2.B RESPONSES TO INDIVIDUAL COMMENTS

LETTER NO. 1**COUNTY OF LOS ANGELES HEARING EXAMINER PUBLIC HEARING TRANSCRIPT**

Figure 2
Site Plan

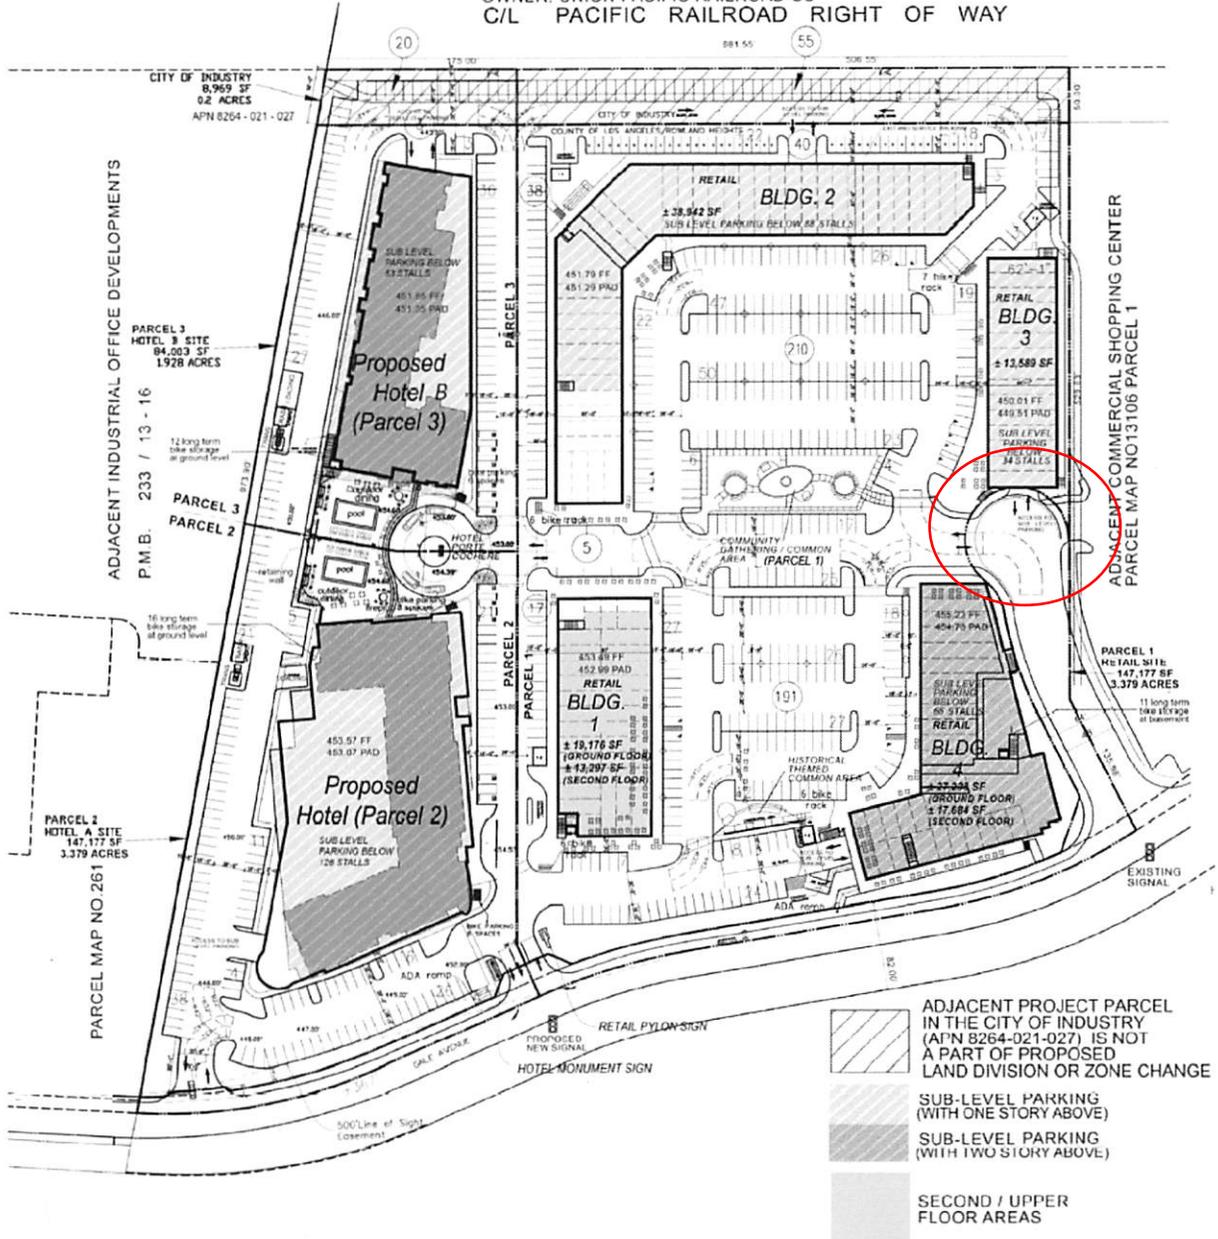
COMMENT NO. 5-11**Figure 2 Site Plan (Please see Figure on the following page.)****RESPONSE NO. 5-11**

This figure, provided on the following page, is the commenter's copy of the Site Plan provided in Section 2.0, Project Description, of the Draft EIR. The commenter has drawn a circle around the shared driveway by the Project's proposed Building 3. Responses to comments regarding the shared driveway are provided above in Responses to Comments 5-2 through 5-10.

Figure 25
Existing Plus Project Saturday
Mid-Day Peak Hour Intersection Turning Movement Volumes

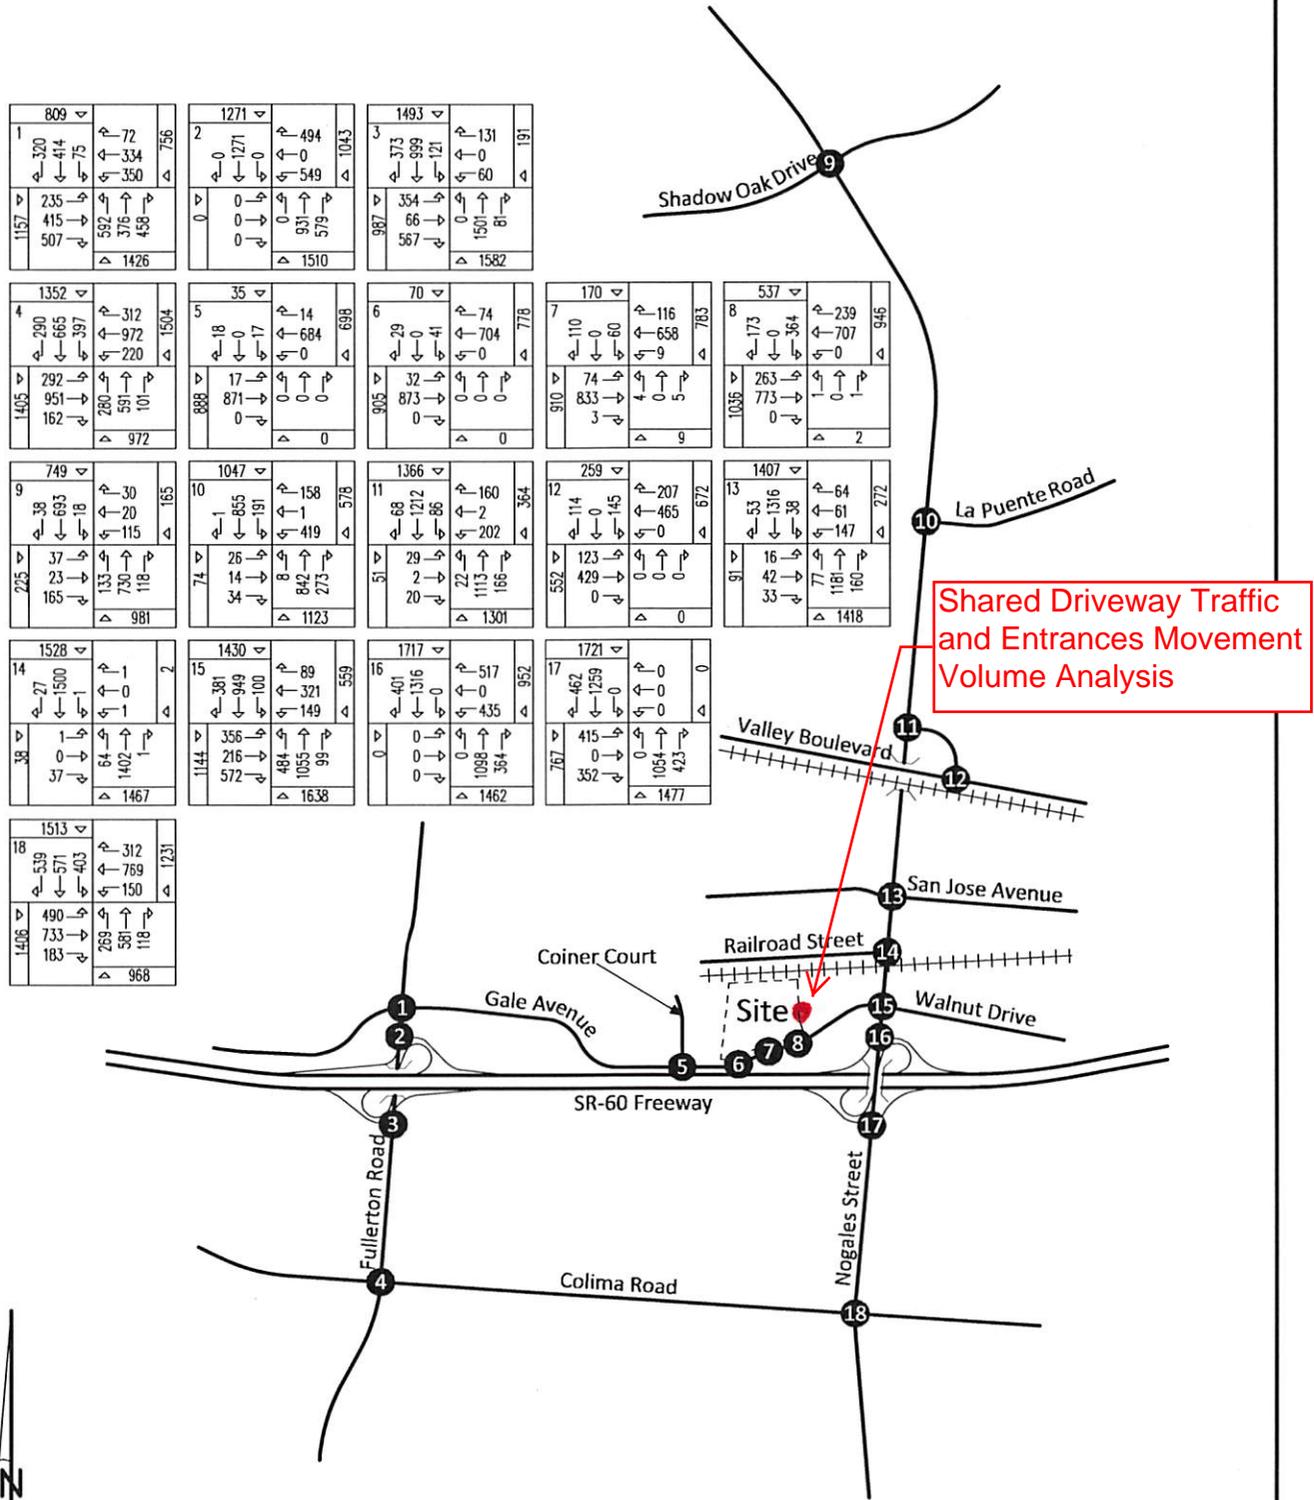
COMMENT NO. 5-12**Figure 4.K-24 Existing Plus Saturday Mid-Day Peak Hour Intersection Turning Movement Volumes****RESPONSE NO. 5-12**

This figure, provided on the following page, is the commenter's copy of the Turning Movement Volumes Figure 4.K-24 provided in the Draft EIR. The commenter has added marking to depict the shared driveway traffic and entrance near Building 3. Responses to comments regarding the shared driveway are provided above in Responses to Comments 5-2 through 5-10.
